NATURAL DRAINAGE RESTORATION PROJECT WORK PLAN

**Former AltX Facility
201 Spring Street
Watervliet, NY**

August 2007

September 7, 2007

FIGURE 3
Former AltX Site
Drainage Restoration

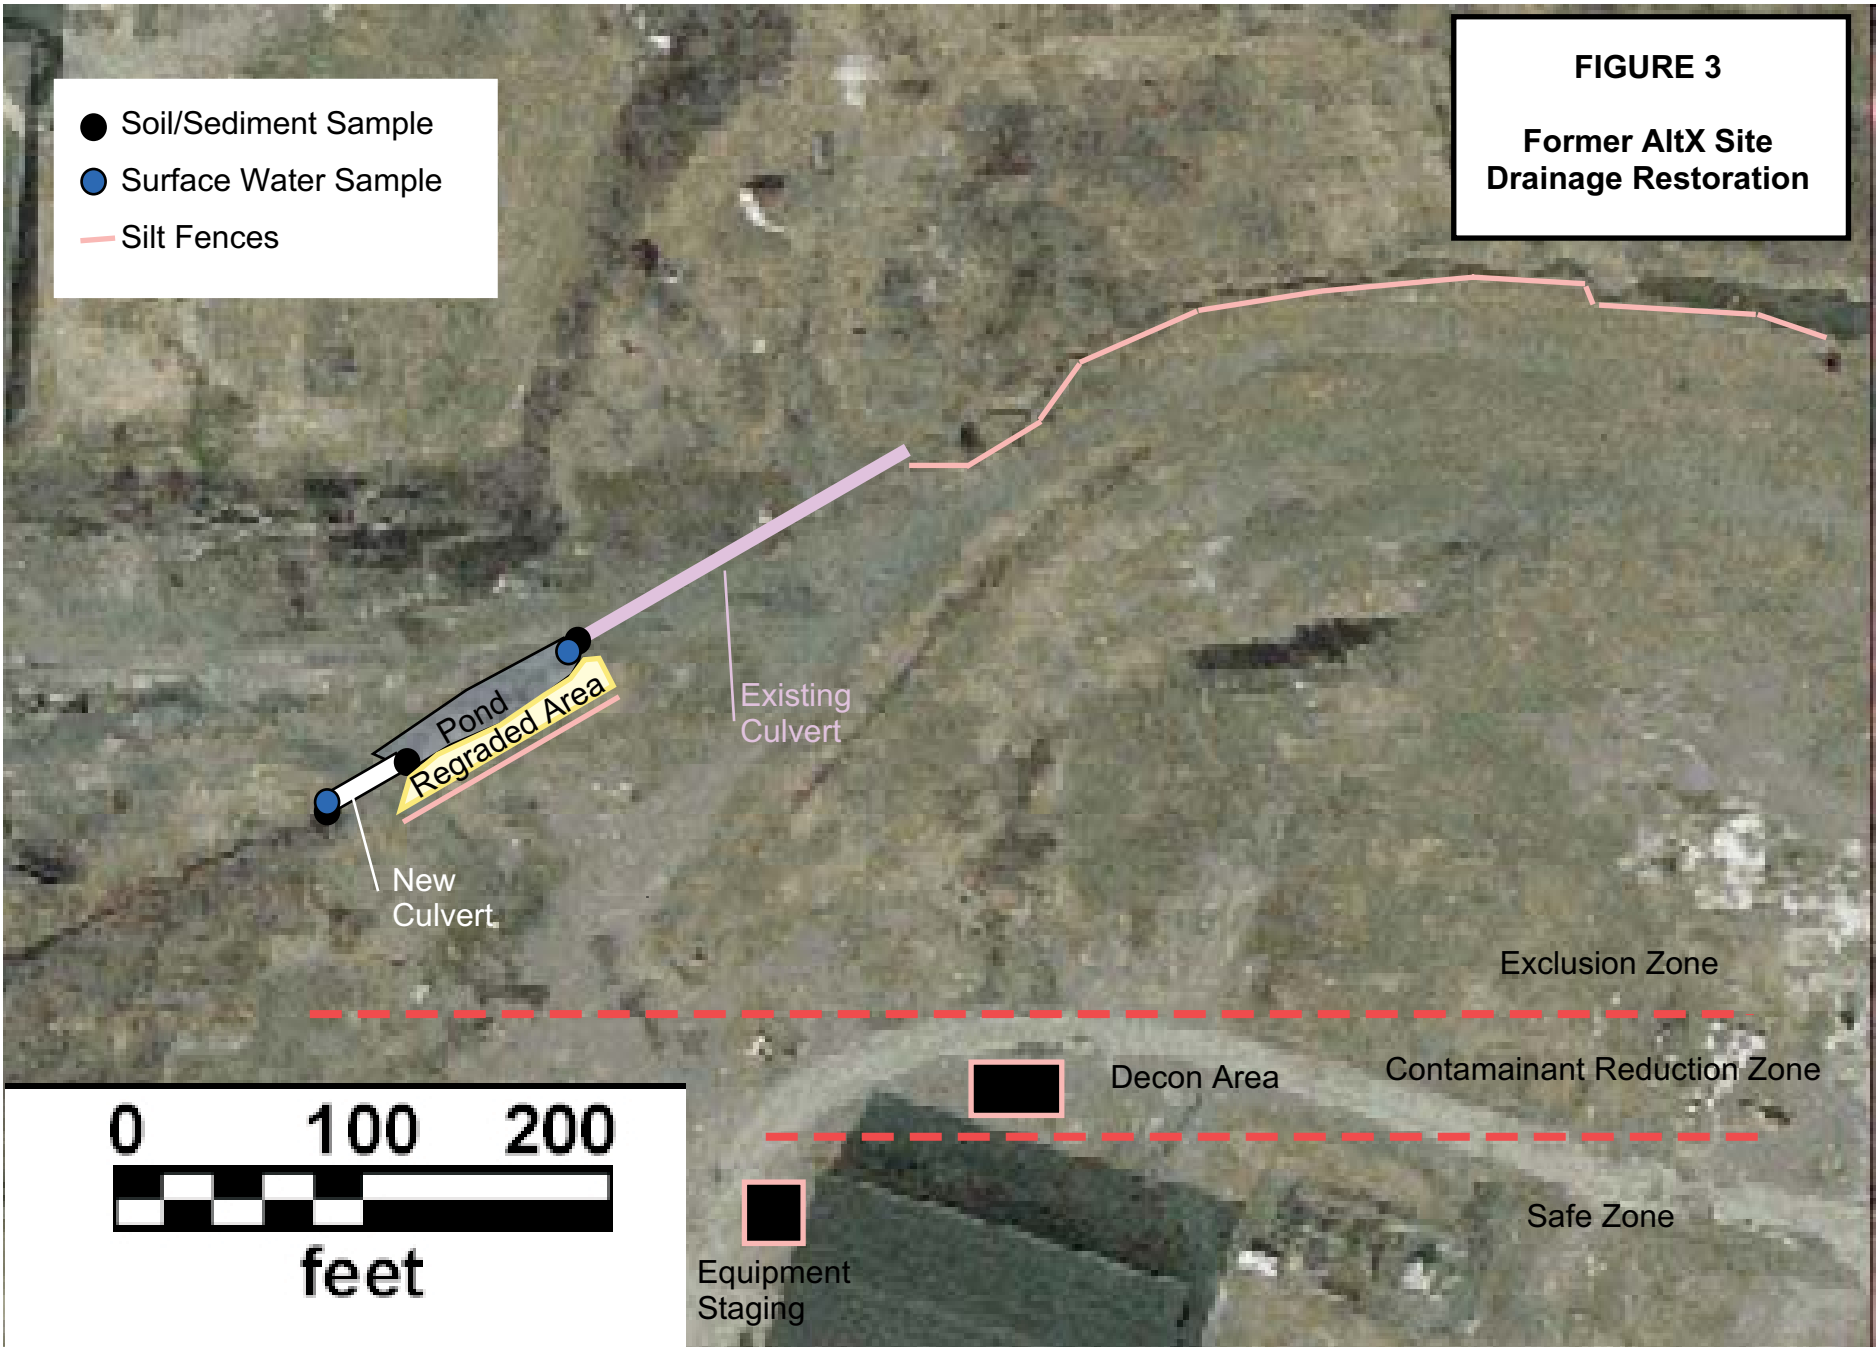
2. Page 3-1: Preconstruction samples are referenced. Is the number and quantity the same as those referenced in Figure 3?

Yes. The figure depicts the locations only. Some of the sample locations are duplicated between the pre and post construction sampling so that the number of dots on the map are actually less than the numeric number of samples.
